June 15, 2012
NRC3-12-0019

Subject: Detroit Edison Company Response to NRC Request for Additional Information Letter No. 70

Response to RAI Letter No. 70
(eRAI Tracking No. 6244)

Response to RAI Letter No. 70
(eRAI Tracking No. 6243)

Figure 03.07.02-6(1) SASSI2000 Plate Elements for RB/FB Basemat

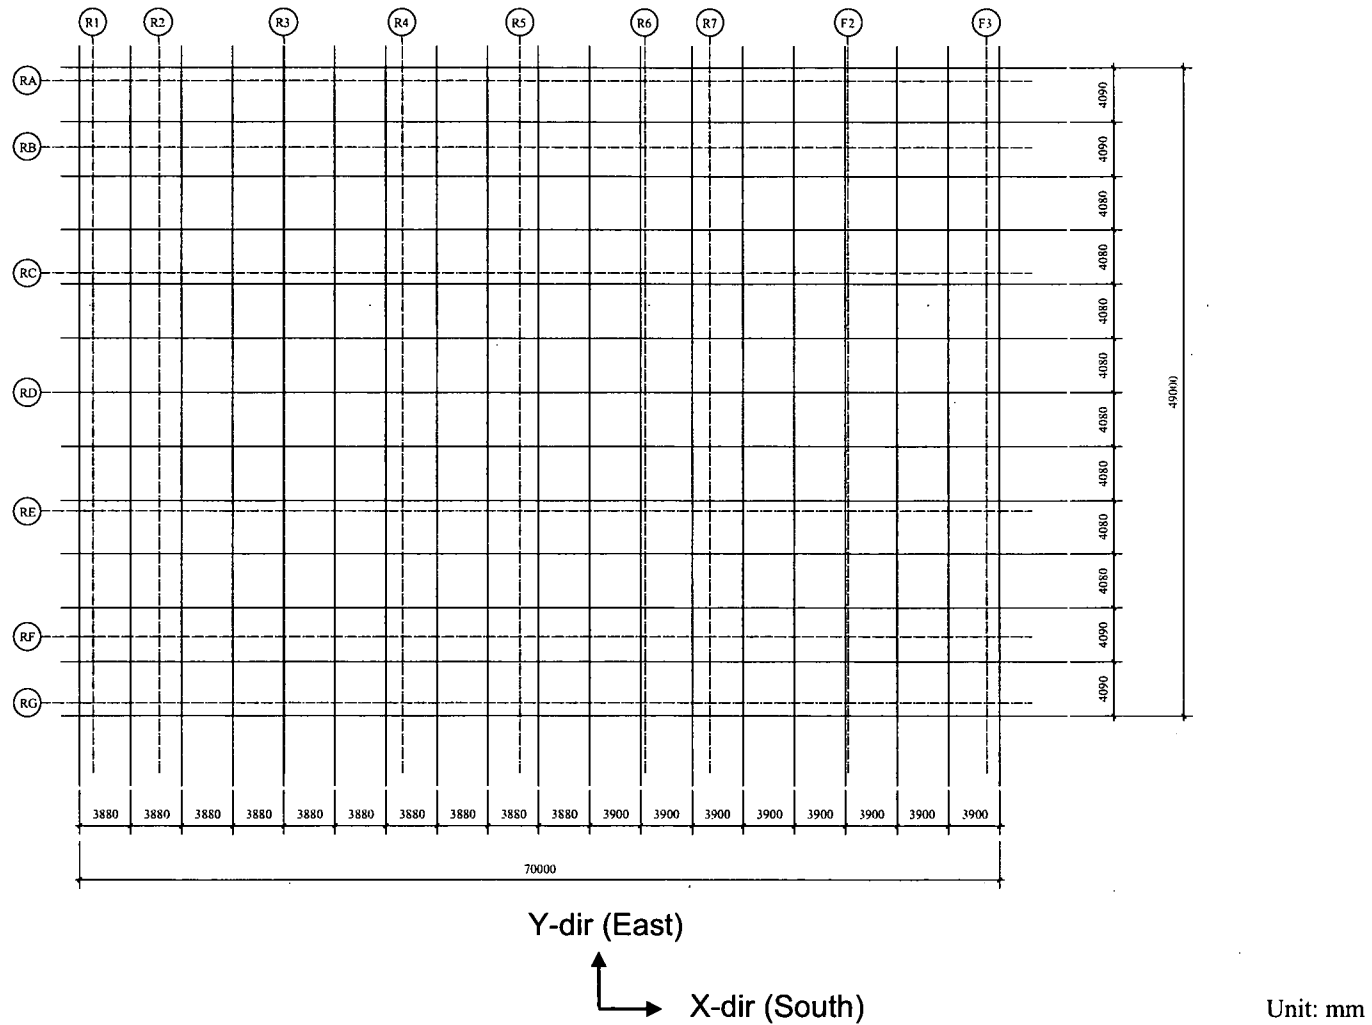
However, EF3 FSAR Figures 2.5.4-201 through 2.5.4-204 show that the RB/FB and CB are deeply embedded structures with two-thirds or more of their depth in the granular fill (above rock and concrete). As such, the applicant is requested to provide further justification for ignoring embedment effects on SSI response. The justification should include the potential impact of this modeling approach on in-structure response spectra (over the entire frequency range of interest), lateral wall pressures, and other seismic loads.

The geometries of the excavated volumes for the RB/FB and CB SASSI2000 analyses are illustrated in Figures 03.07.02-6(1) through 03.07.02-6(6). The excavated volume is modeled from the top of the finished ground level grade (EL 4,500 mm) to the bottom of the basemat foundation. For the RB/FB, the bottom of the basemat foundation is EL -15,500 mm and for the CB, the bottom of the basemat foundation is EL -10,400 mm. The RB/FB stick model is connected to the basemat and side walls at floor EL -11,500 mm, -6,400 mm, -1,000 mm, and 4,500 mm by a set of rigid links shown in red on Figure 03.07.02-6(3). The CB stick model is connected to the basemat and side walls at floor EL -7,400 mm, -2,000 mm, and 4,500 mm by a set of rigid links shown in red on Figure 03.07.02-6(6). At the top of the basemat for the RB/FB and CB models at EL -11,500 mm and EL -7,400 mm, respectively, a rigid link is used to connect the stick models to the center of the each basemat.

Figure 03.07.02-8(2) Structure-Soil-Structure Interaction Analysis Procedure

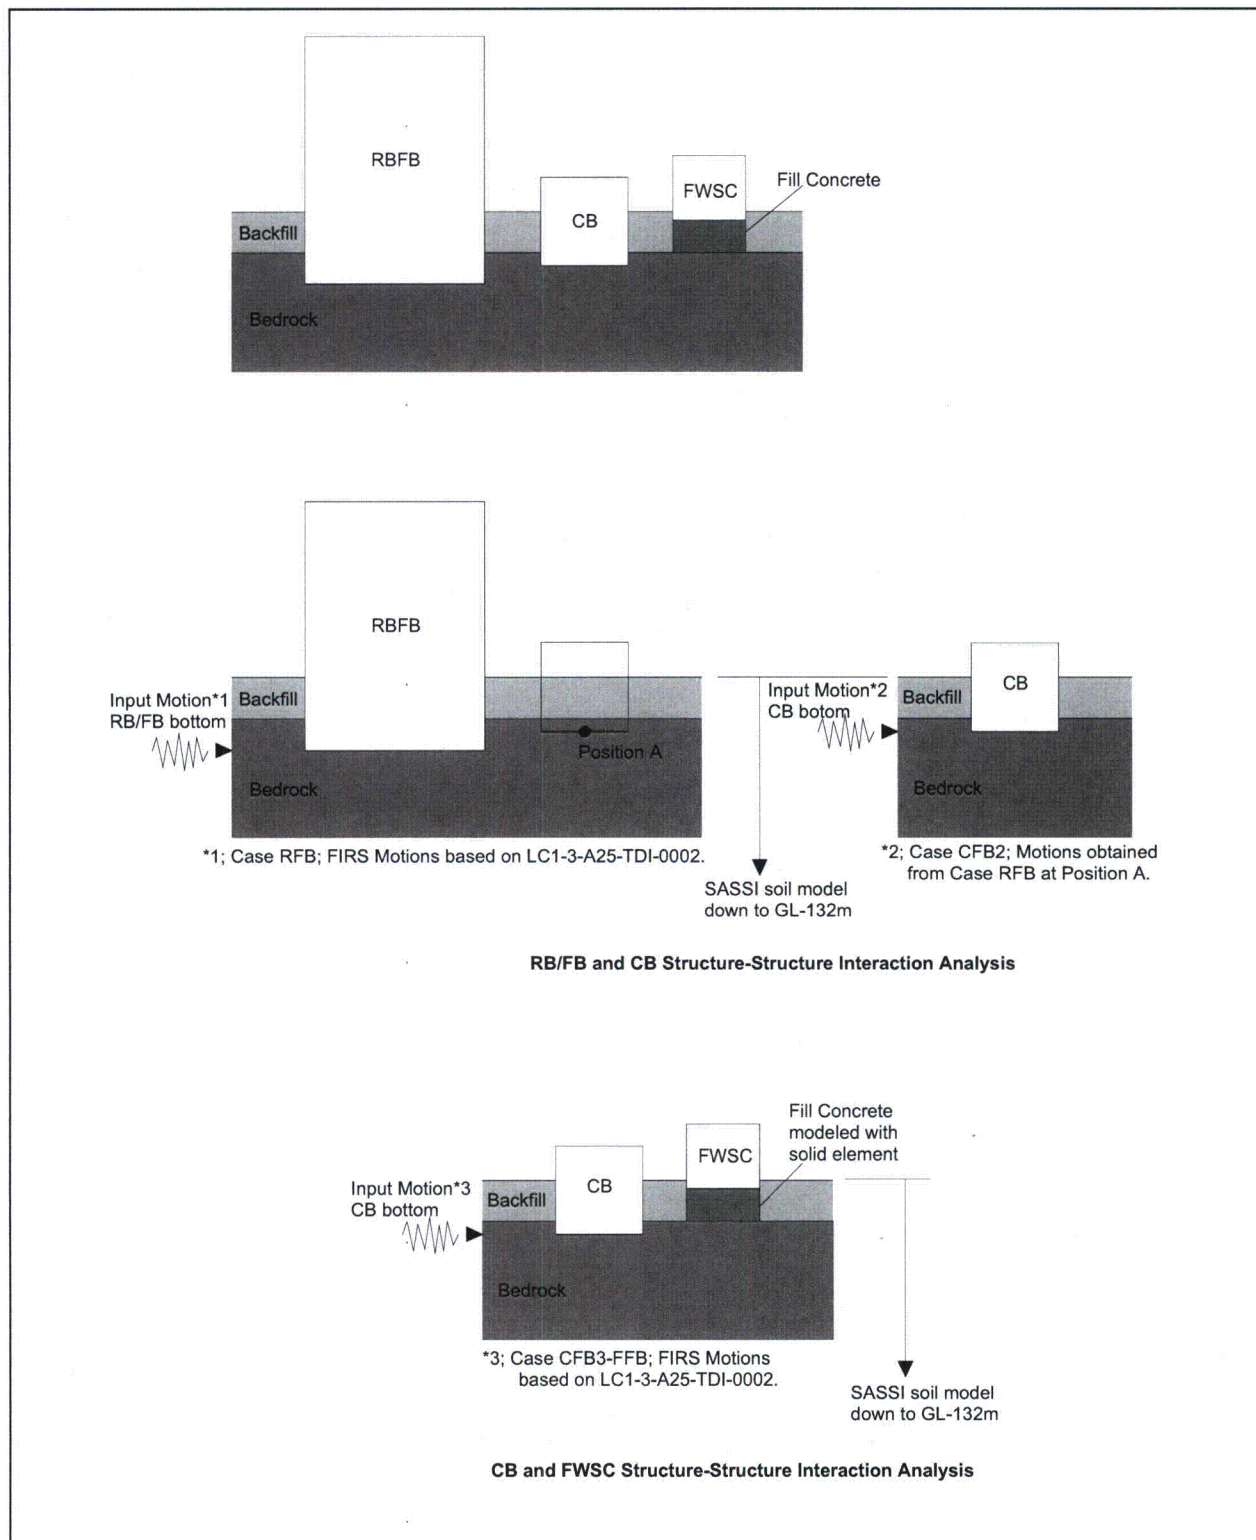
EF3 FSAR Figure 2.5.4-202, as modified by the markups included with the response to RAI Letter 55 Question 02.05.04-38, shows a cross section through the RB/FB, CB and FWSC with the extent of concrete fill and granular fill. Since these site conditions deviate significantly from cases CL-6 and FL-5, analyzed in the ESBWR DCD, the applicant is requested to explain how SSSI effects are evaluated between these structures. What is the basis for neglecting the granular fill in the site-specific analyses in the context of SSSI, given that these structures are deeply embedded and in close proximity to each other? What is the basis for including concrete fill between the RB/FB and CB gap? Does the addition of the stiff concrete fill between the CB and the RB/FB introduce potential interaction between the two structures?

The RB/FB SSSI effects on the CB are more significant than the CB SSSI effects on the RB/FB, because the size of the RB/FB is much larger than the CB. To evaluate the RB/FB effects on the CB, the analyses are performed by the following two steps as shown in Figure 03.07.02-8(2):

Figure 03.08.05-4(1)a Lateral Soil Pressure including RB/FB SSSI Effects - CB C1 Wall - Case CFB2

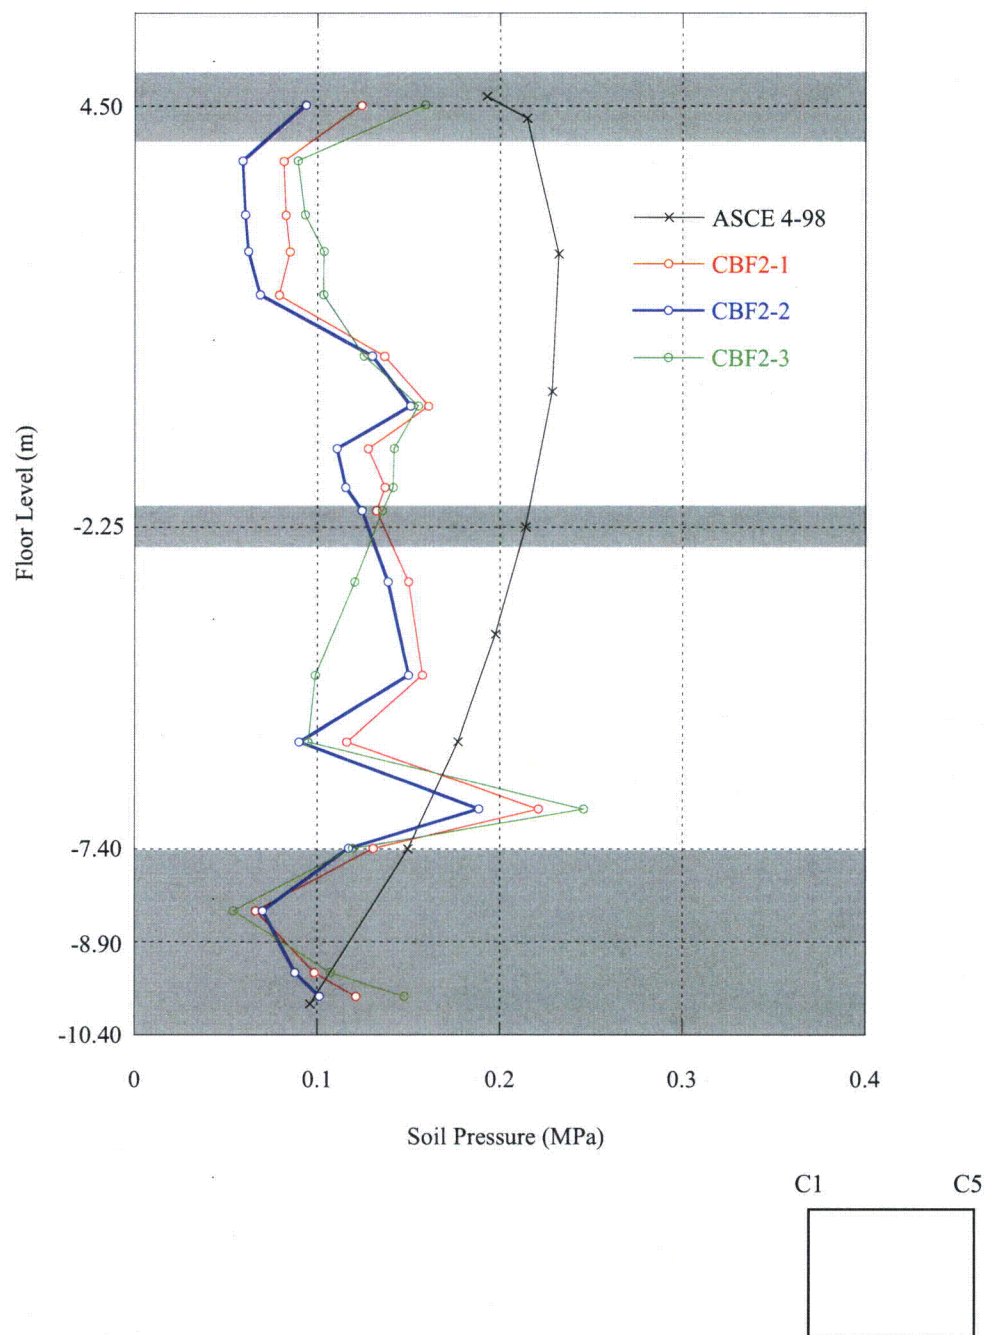
03.08.05-4	3	(c) Provide estimates of additional static and dynamic lateral pressures imposed from adjacent Seismic Category I and II structures. This should also include possible effects of structure-to-structure interaction through the surrounding backfill, concrete fill, or rock.	June 15, 2012

Figures 03.08.05-4(1) and 03.08.05-4(2) show the lateral soil pressures on the CB imposed from the RB/FB (Case CFB2) and FWSC (Case CFB3-FFB), respectively. These pressures are compared with the lateral soil pressures computed from the equivalent static pressure analysis in ASCE 4-98.
